### **Visual Impact from nearby residences.**

Trustpower and their consultant Green Bean Design were asked to assess the Visual Impact of the revised Rye Park wind farm on non-associated residences within 3 kilometres of a turbine.

Uninvolved residence(s) dwelling R324 - Proposed view through 120°. Approximate distance to closest visible wind turbine 1,784 m

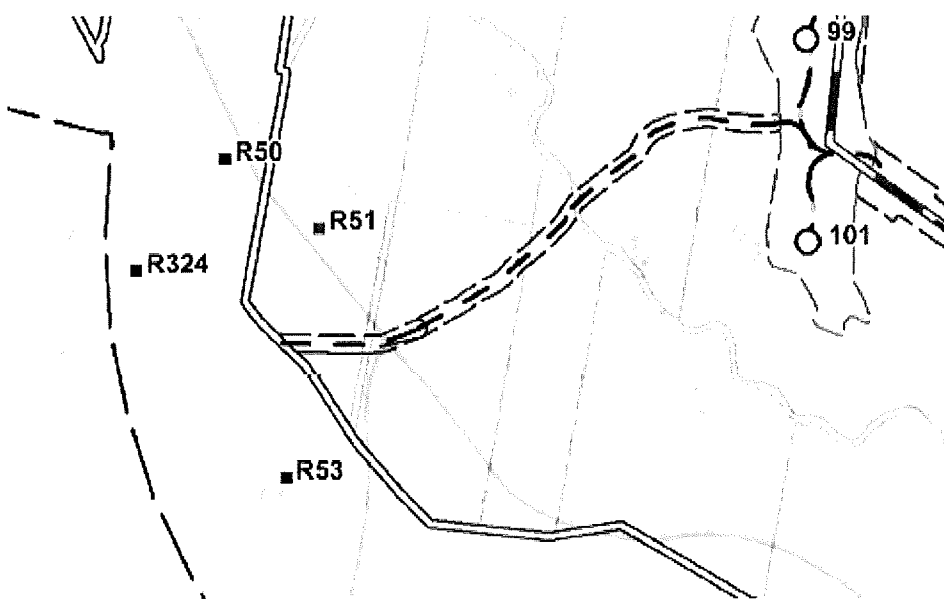
Is the photo taken from the residence? No, it is taken at the entrance to the property 160 metres away.

Is the residence in the photo R324? No it is R50.

Which turbines are in the photomontage? Who knows, without significant extra work.

Is the panoramic photo centred at the nearest turbine? No, the nearest turbine (101) is at the extreme right, behind the tree, if it makes it into the photomontage at all.

All wind farm landscape architects should know by now not to have foreground vertical objects in their photomontages. GBD could have walked to the other side of the tree and taken the photographs. This is one of many similar examples. For this and other reasons, the whole of the photomontage section of the LVIA is therefore highlighted in the “Neither false nor misleading section” of this submission
